This Preliminary Amendment is to clarify portions of the Application, including the Specification and Claims, to add a new claim, to add a replacement Abstract of the Disclosure, and to amend the Drawings. Also included are a Substitute Specification, a marked-up copy of the Substitute Specification showing the changes made and an English-translation of the International Application. No new matter has been added.

**MARKED-UP COPY**  
**OF SUBSTITUTE SPECIFICATION**

~~SOLID BOWL SCREW CENTRIFUGE COMPRISING A SCRAPING BLADE~~  
~~CENTRIPETAL PUMP~~

*Fig. 4*  
PRIOR ART

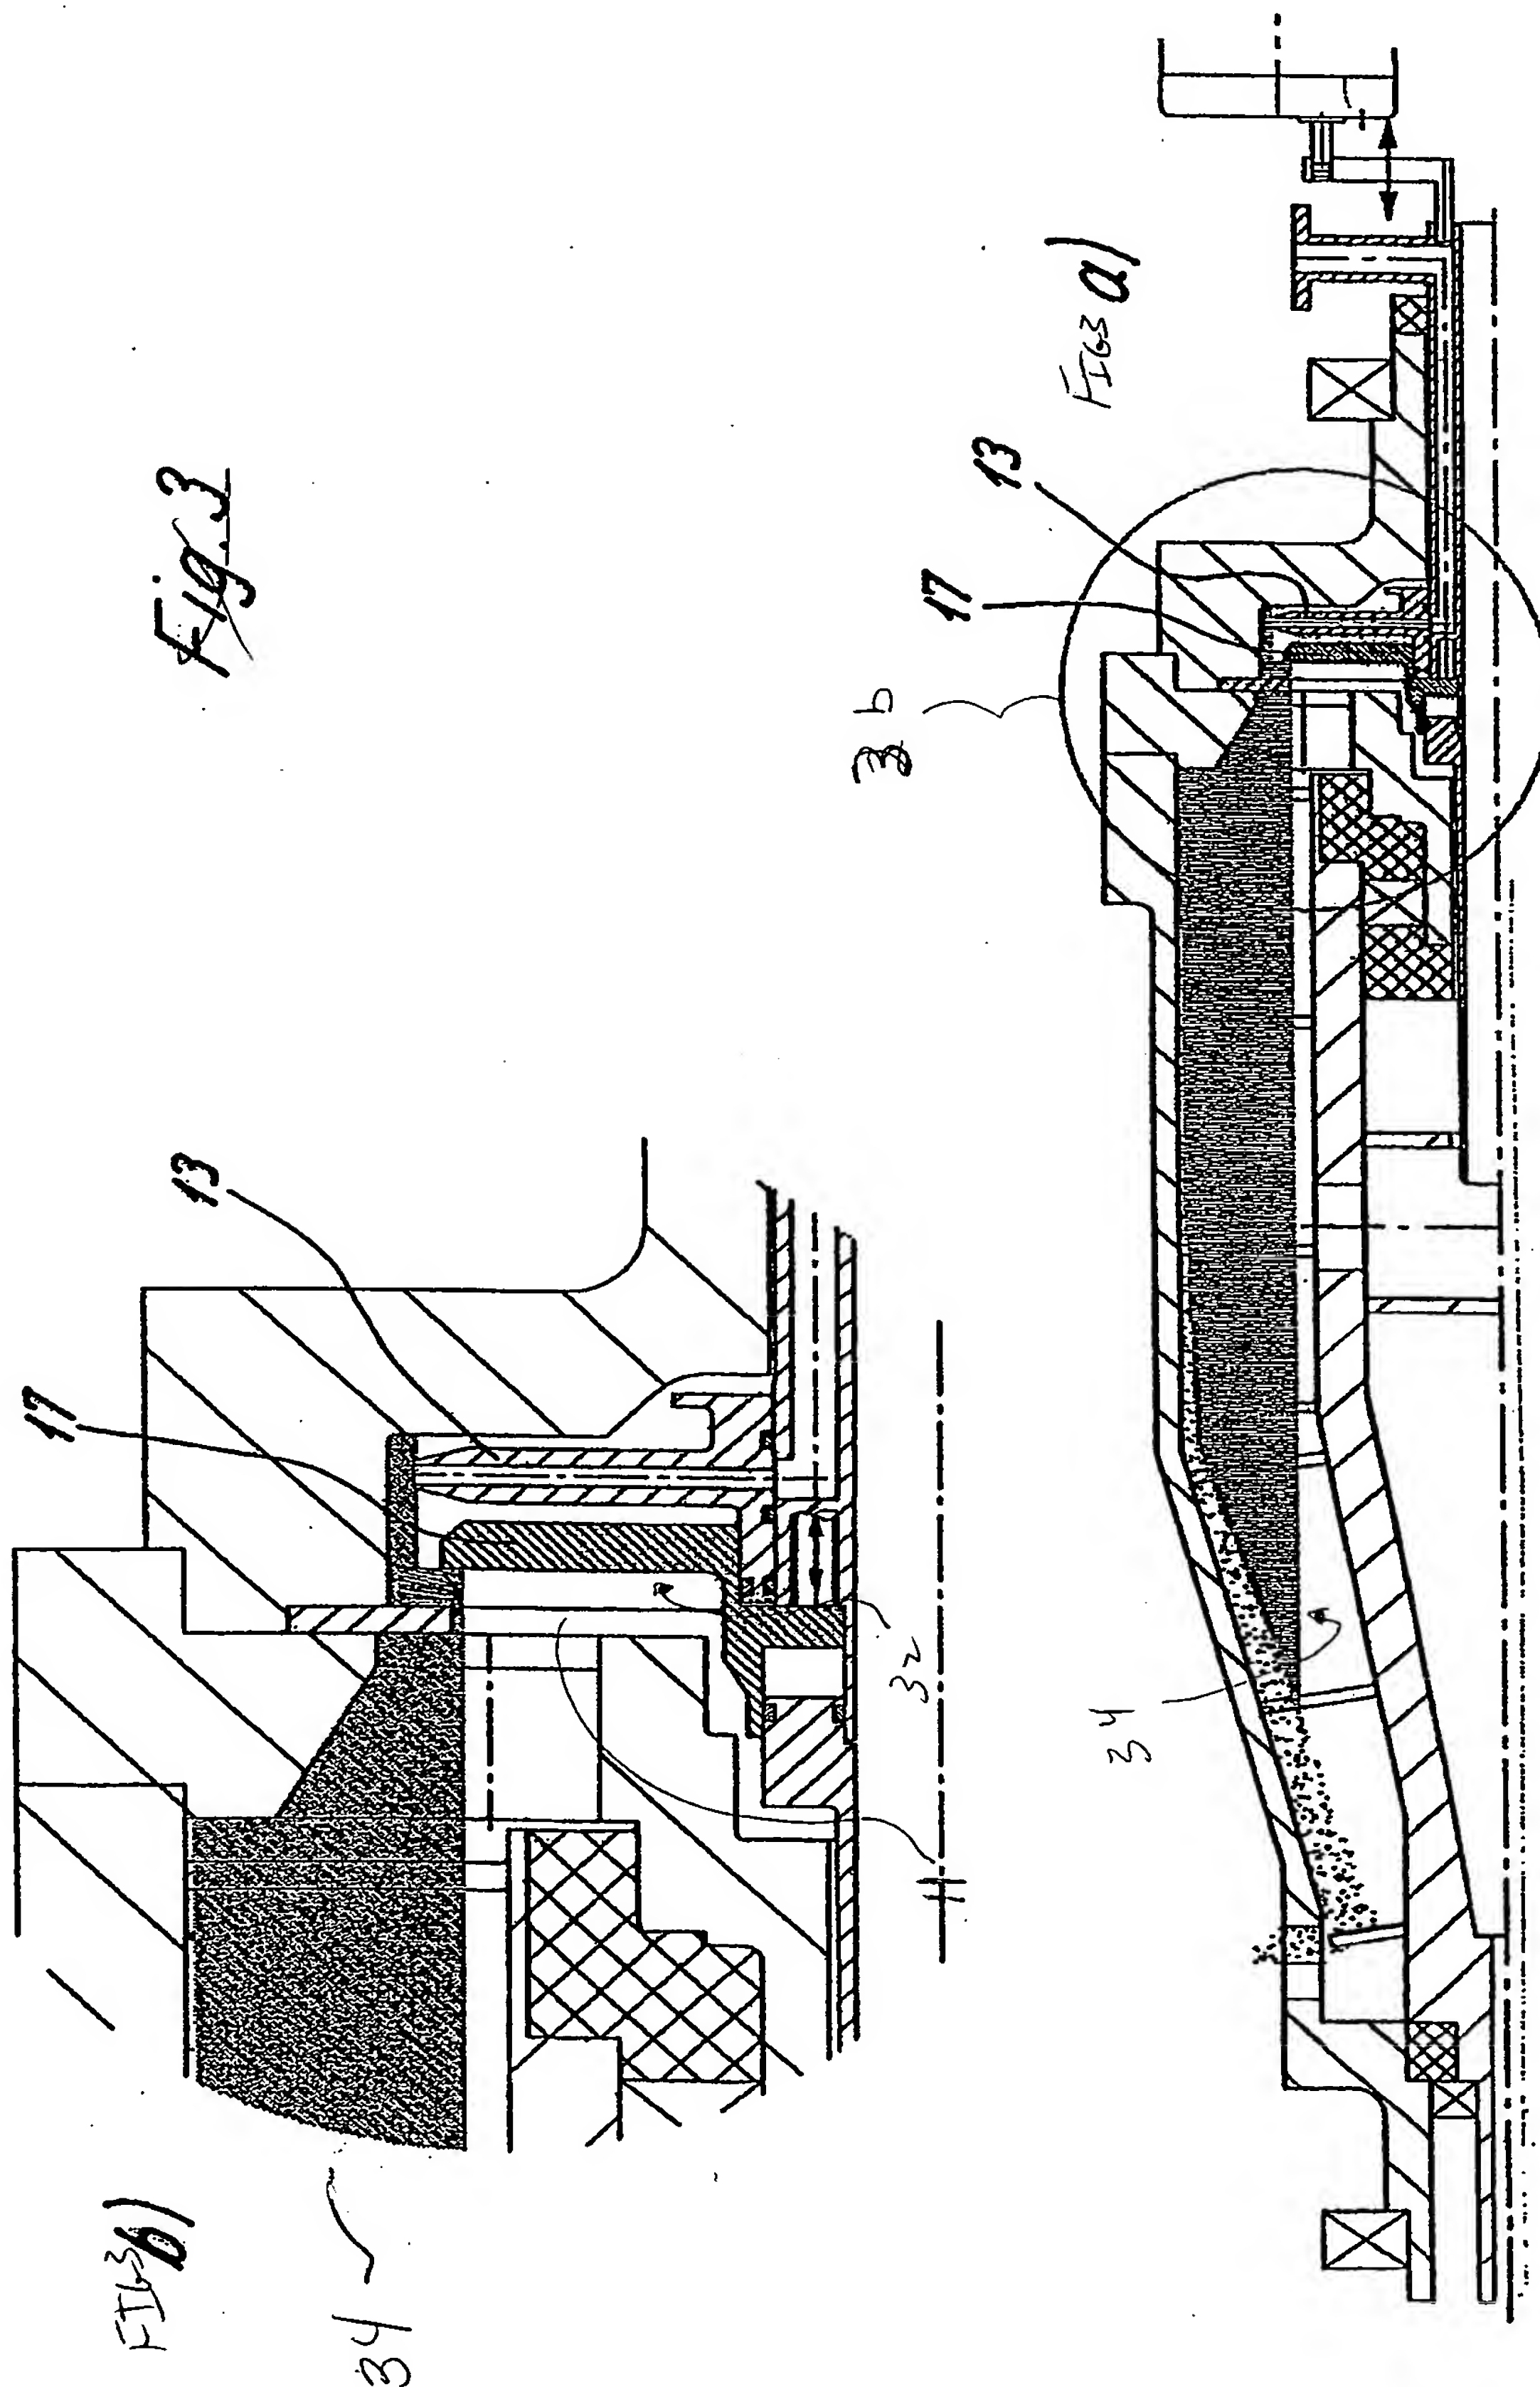
~~29~~[00028] Figure 4 is a sectional view of a drum of a solid bowl screw centrifuge according to the state ~~of the art~~ prior art.

**[00040]** Figure 4 shows a solid bowl screw centrifuge according to the state of the art, where no throttle disk 17 is arranged in the centripetal chamber section.
